**BEFORE THE OFFICE OF ENERGY INFRASTRUCTURE SAFETY  
OF THE STATE OF CALIFORNIA**

**COMMENTS OF THE GREEN POWER INSTITUTE  
ON THE SDG&E 2026-2028 WILDFIRE MITIGATION PLAN**

June 13, 2025

**Figure 1.** Risk-neutral and risk-averse consequence functions and effective sliding scales for structures per fatality or VSL.

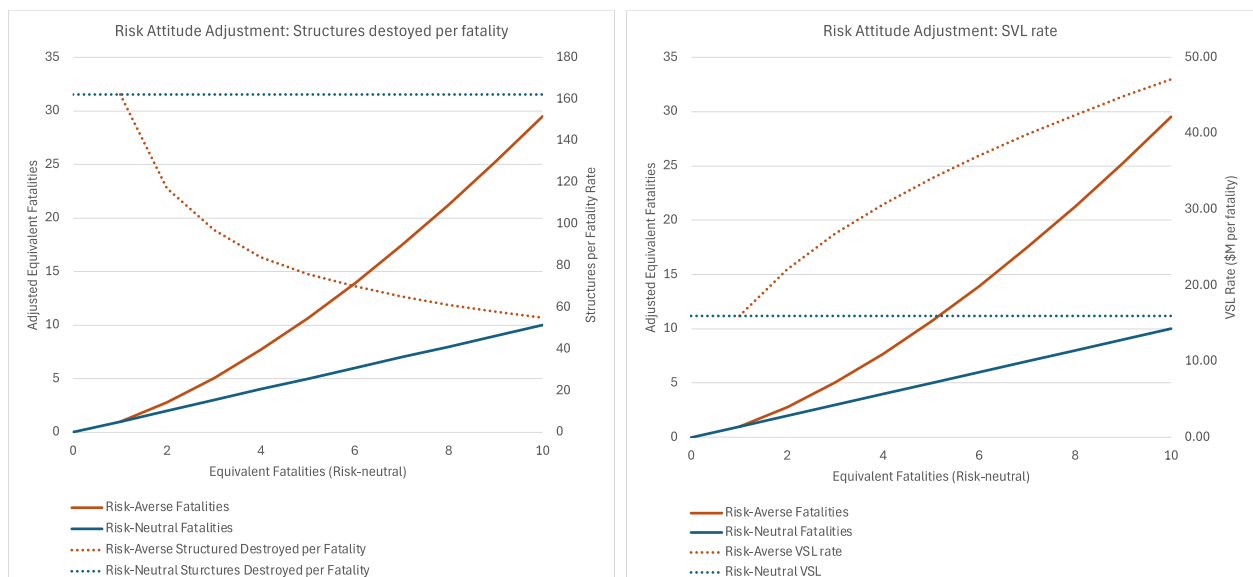
SDG&E's risk-averse safety function pushes the portfolio selection in favor of safety considerations versus affordability. Amplifying the anticipated equivalent fatalities in the numerator of the BCR permits an increase in mitigation investment cost in the denominator, towards a BCR of 1. The safety risk-averse function can be conceptualized in terms of a sliding scale of fatalities per structure or Value of Statistical Life (VSL). SDG&E reports a Safety consequence value of 0.00617 fatalities per structure or 1 fatality per 162 structures

destroyed, based on its assessment of CAL FIRE data.<sup>2</sup> SDG&E's adjusted equivalent fatalities risk-averse function can be thought of as modifying this conversion factor when predicted fatalities exceed 1—At 10 predicted fatalities, the effective risk-averse conversion rate becomes 1 fatality per 55 buildings destroyed (0.01822 fatalities per structure). Similarly, put into context of VSL, SDG&E's risk-neutral rate is \$15.97M per predicted fatality (2025), while its risk-averse rate for 10 predicted fatalities essentially increases the VSL to \$47.1M per predicted fatality. The Safety risk-averse function can be considered the same as adopting a sliding scale for consequence attribute valuation rates (Figure 1). SDG&E applies similar risk averse function to Reliability and Financial consequence attributes.

Framing the risk-averse function relative to baseline consequence values puts it in context. As defined, VSL is the collective or average willingness to pay for a reduction in mortality risk. A sliding VSL scale raises questions as to whether it is appropriate to assume that Californians are willing to pay more for utility wildfire risk mitigations based on a VSL

multiple times greater than its baseline value of \$15.97M. Or whether it is appropriate to depart from CAL FIRE data informed fatality to building destruction ratios. This same question applies to SDG&E's Reliability and Financial attributes and risk-averse functions. Assuming a BCR  $\geq 1$  qualifies as a cost-effective mitigation, a sliding scale that increases attribution risk value will also permit a concomitant increase in mitigation cost, or the cost ratepayers are willing to pay to mitigate the risk.

SDG&E's risk averse functions essentially build in a low risk-tolerance attitude that departs from CAL FIRE fatality data and baseline VSL, building cost, and value of outage minutes. The foundational questions that must be answered are whether the sliding valuation scales (1) reflect a ratepayer versus utility risk aversion attitude and/or (2) appropriately account for model uncertainty. The baseline VSL, building cost, and value of outage minutes reflect external studies and traceable data inputs (e.g. average structure cost, CAL FIRE database, Technosylva simulations) that are more readily defensible as ratepayer incurred costs and risk attitude. In contrast, SDG&E's elective risk-averse scaling factor is at least partially informed by utility risk attitude.

**Figure 1.** SDG&E Reported CCC and Undergrounding costs, adjusted to include a 1.2 overhead to undergrounding factor and showing cost adjustments based on PG&E’s average Undergrounding CapEx cost.

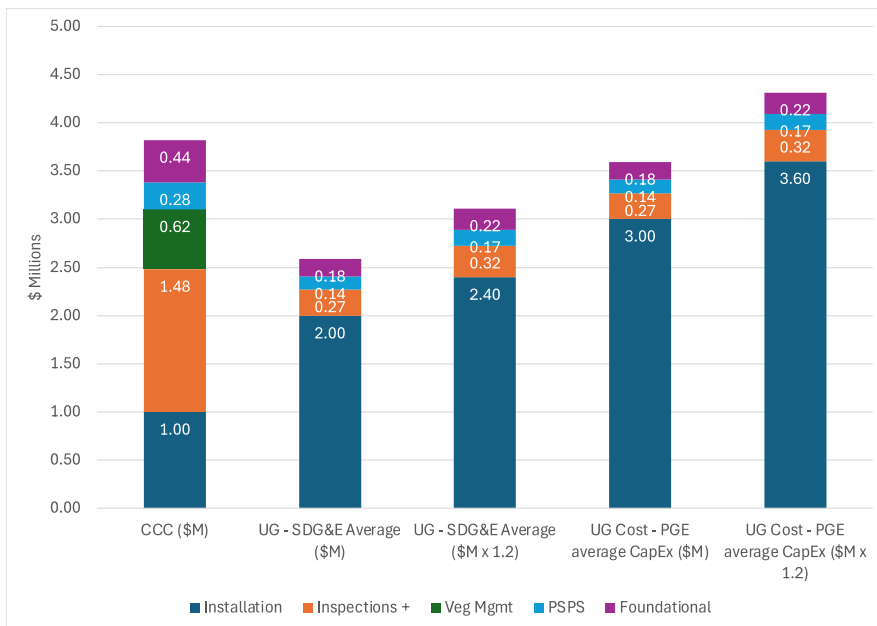
SDG&E's CCC versus Undergrounding per mile figure, presented in the WMP Workshop, was not included in the WMP. While these values can be somewhat discerned from SDG&E's WMP Appendix G, the figure should have been, and should now be, included in the WMP—this is a foundational input that determines BCR and provides BCR calculation transparency. The cost comparison figure also chooses to leave out the 120% overhead to undergrounding correction factor for the conversion of 1 mile of overhead system to approximately 1.2 miles of undergrounding (Figure 1).

SDG&E's lifecycle costs for undergrounding raise questions about accuracy. The projected CapEx average of \$2 Million per mile undergrounding cost is two thirds that of PG&E. Applying the distribution system expansion factor for overhead to undergrounding (x1.2) and increasing the average installation cost to PG&E's \$3M estimate would increase the cost of undergrounding above SDG&E's CCC lifecycle cost. SDG&E's HFTD territory includes

watersheds, vegetation coverage, bedrock exposure, steep terrain, and faults, all of which the Utilities identify as challenges that can increase undergrounding cost. SDG&E should be required to provide additional data substantiating that it can achieve an average undergrounding installation cost that is much lower than the other IOUs.

SDG&E’s UG lifetime costs do not include any vegetation management O&M costs, which is suspect since SDG&E’s own public outreach materials refer to required VM work for undergrounded infrastructure.<sup>3</sup> Other utilities offer more transparent VM standards for undergrounded electric lines and pad mounted equipment, including a 3’ and 10’ clearance from pad mounted equipment and the service doors, respectively, and “right tree, right
